Application for Assessment of a Site Investigation Report (Contaminated Land) Checklist

Location: 320-324 Vulture St, Kangaroo

Decision: : **Assessment of an Investigation Report**
Section: : **s.384, Environmental Protection Act 1994**
Applicant : **Gary Gough**
Site Owner : **Phillip Usher Constructions Pty Ltd**
Property details : **Lots 9 & 10 RP 114612 and Lot 1 RP 11190**
Site Location : **320-324 Vulture Street**
54 Mark Lane, Kangaroo Point
Consultant : **Australis Contract Engineering Pty Ltd**
FILE : **BNE 8920**

CLIENT Philip Usher Constructions		PROJECT Stage 1 PSI Kangaroo Point 320-324 Vulture Street, Kangaroo Point						
	DRAWN REJ	DATE 30/11/07	TITLE SITE INVESTIGATION LOCATIONS						
	CHECKED *CW	DATE 8/02/08							
	SCALE 1:400 APPROX		PROJECT No	001-077633089	FIGURE No	3	REV No	0	A3

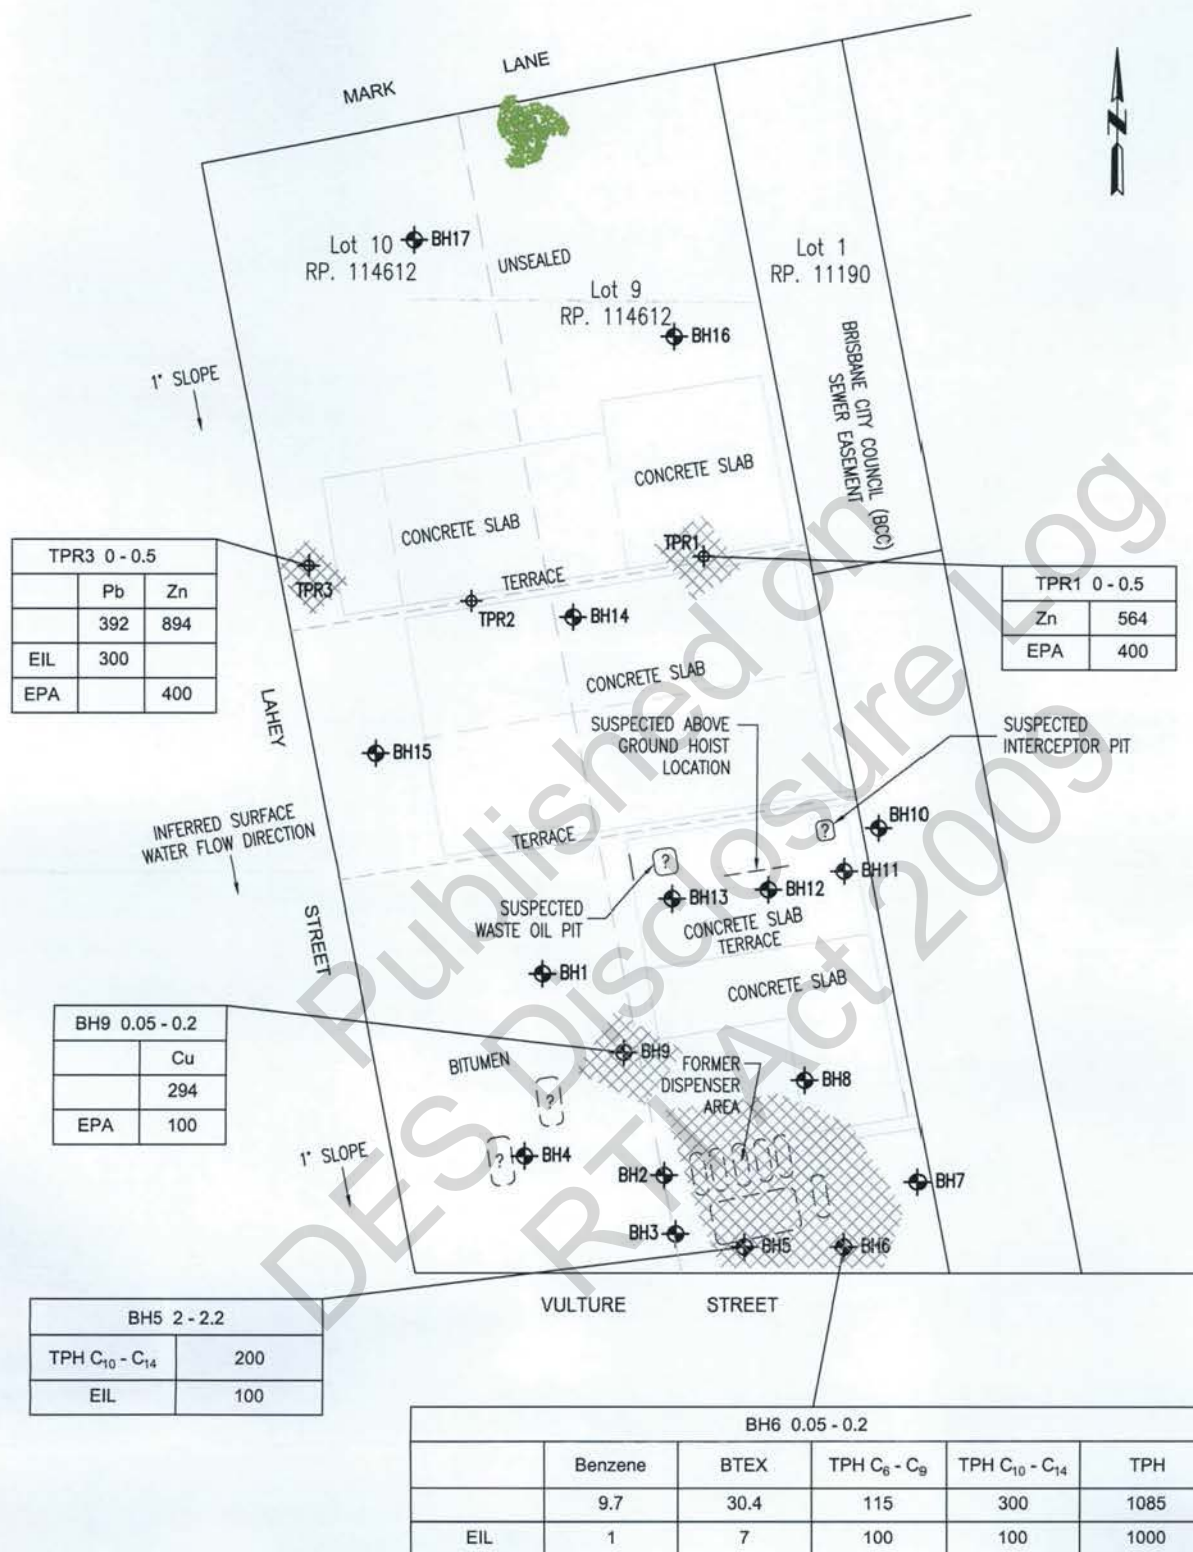
- Paragraph 3 – “diesel and unleaded petrol are known to have been stored on the site” – based on what information?
 - Paragraph 6 – “sump” is this the same as the oil pit in *Figure 3*. Have these areas been sampled?

- Check spelling "Phillip" should be "Philip".
- Figure 3 –
 - Provide the location of the Hoist, Interceptor and Waste Oil UST. Can the extent of the lead be delineated?
- Figure 4 –
 - Provide a key for shaded areas.
 - Why is the area shaded south of BH15 and BH17 and how is the extent of impact known based on 1 bore?
 - How is the NE extent of impact known in the shaded area above BH6?
